Planning Committee

Wednesday, 3 March 2021, 6.00pm

PC2103-2 KEEL PLACE, NO. 4 (LOT 51), NORTH FREMANTLE - THREE STOREY SINGLE HOUSE AND ANCILLARY DWELLING (TG DA0166/20)

Additional Information 2 – Original Officers Report

CITY OF FREMANTLE
Planning Approval for DA0166/20
was REFUSED on
4 November 2020
Plan 5 of 8

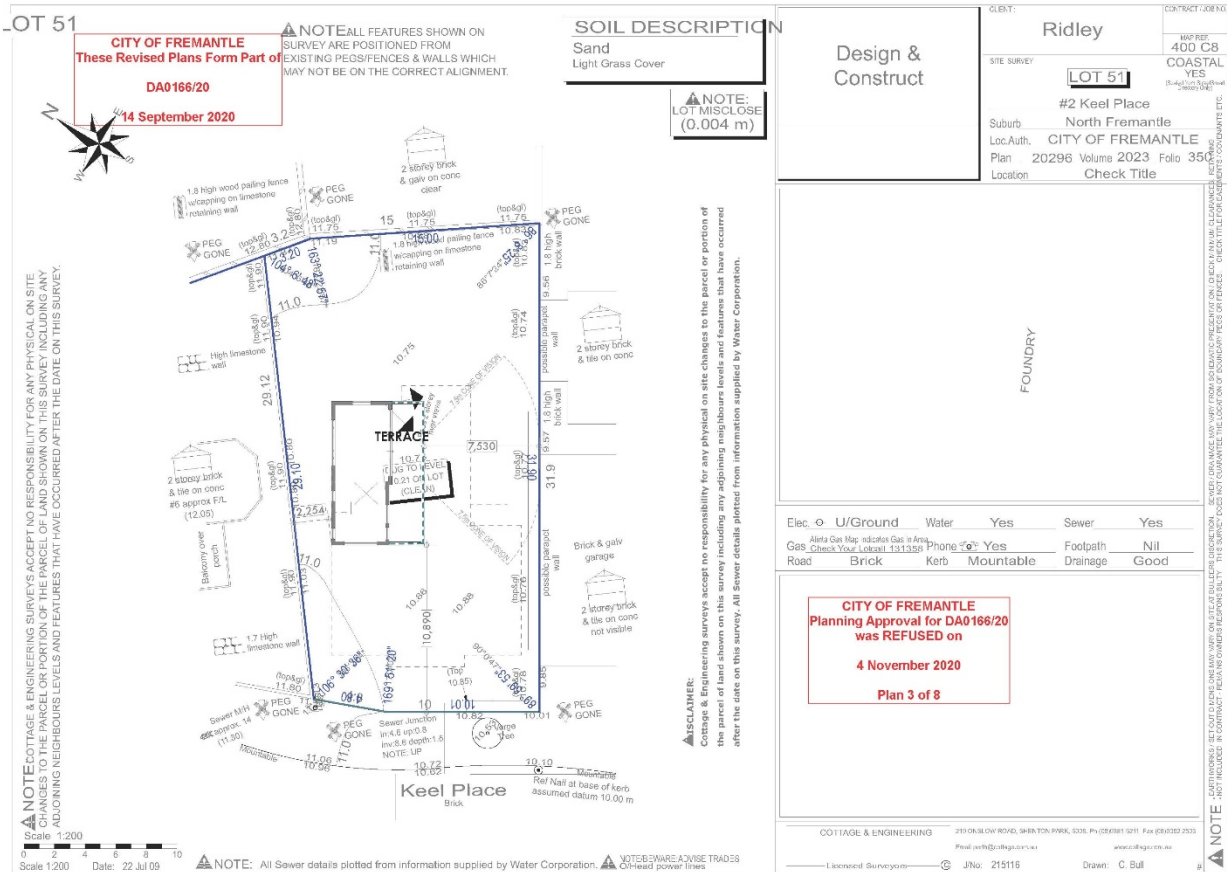
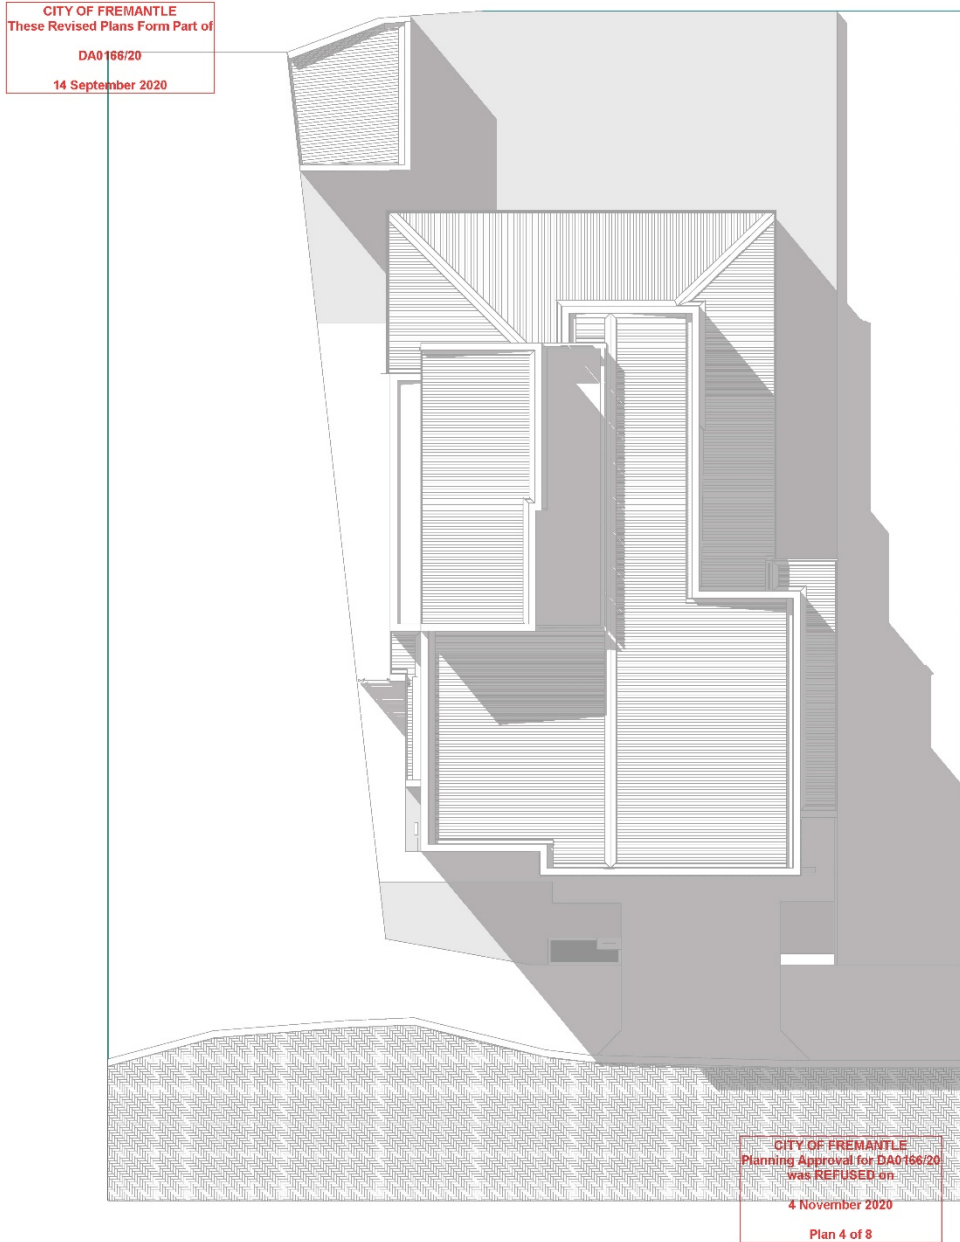
REFUSE, under the Metropolitan Region Scheme and Local Planning Scheme No. 4, three storey Single house and Ancillary dwelling at No. 4 (Lot 51) Keel Place, North Fremantle, as detailed on plans dated 14 September 2020, for the following reasons:

1. The proposal is inconsistent with the requirements of the City of Fremantle Local Planning Scheme No. 4 in respect to building height requirements of Local Planning Area 3, sub area 3.3.1 and does not satisfy the discretionary criteria of clause 4.8.1.
